**This is an alternative suggested remedy for the comment #182.**

The Draft 2.0 has the following text:

Figure 143–16—MCRS Receive Function, Output Process state diagram

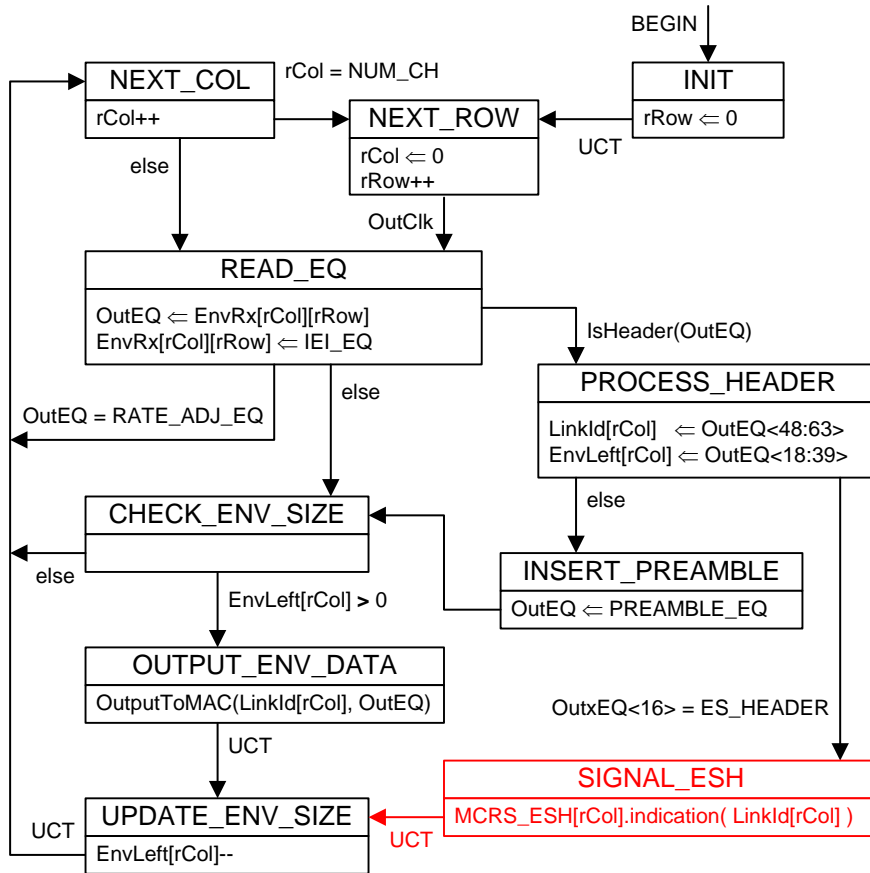
- 1) MCRS Output process generates *MCRS\_ESH[ch].indication()* every time it reads an ESH from the *ENV\_RX* buffer. This indication is similar to *TS\_RX.indication()* primitive used by the Clause 90 for time synchronization.

### 143.3.1.2.3 MCRS\_ECH[ch].indication( Llid ) primitive

The Output Process (see Figure 143–16) generates the *MCRS\_ECH[ch].indication( Llid )* primitive every time an ESH EQ is read from the *ENV\_RX* buffer. This primitive causes the MPMC Control Parser Process (see 144.2.1) to generate a local timestamp (i.e., to latch the local MPCP time) representing the arrival time of ESH EQ.

Figure 144–5—Control Parser state diagram

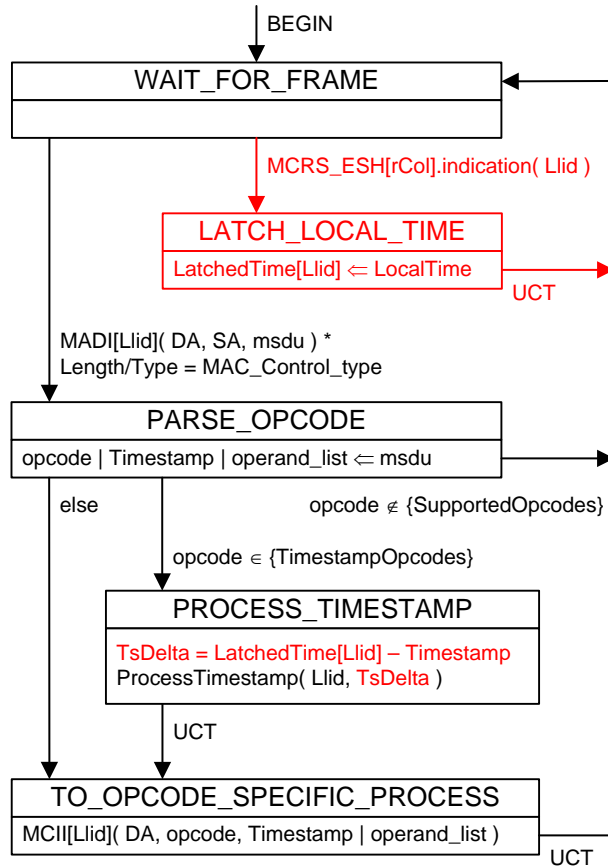
- 2) The MPMC Control Parser latches *LocalTime* value into *LatchedTime[LLid]* variable at the moment it receives *MCRS\_ESH[ch].indication()* primitive.

### LatchedTime[]

Type: An array of 32-bit unsigned integers

Description: Each element of this array represents the value of *LocalTime* variable (see 144.2.1.2) latched at the moment when the *MCRS\_ESH.indication( Llid )* primitive was generated. The elements of the array are indexed by the *Llid* values.

### TsDelta

Type: 32-bit signed integer

Description: This variable represents the difference between the time that ESH was read from the MCRS *ENV\_RX* buffer (i.e., the *LatchedTime[ Plid ]*) and the *Timestamp* value in an MPCPDU that followed that ESH. In the ONU, the *TsDelta* is used to adjust the *LocalTime* value, while in the OLT it is used as the measurement of the round-trip time to the ONU that sourced the given MPCPDU.
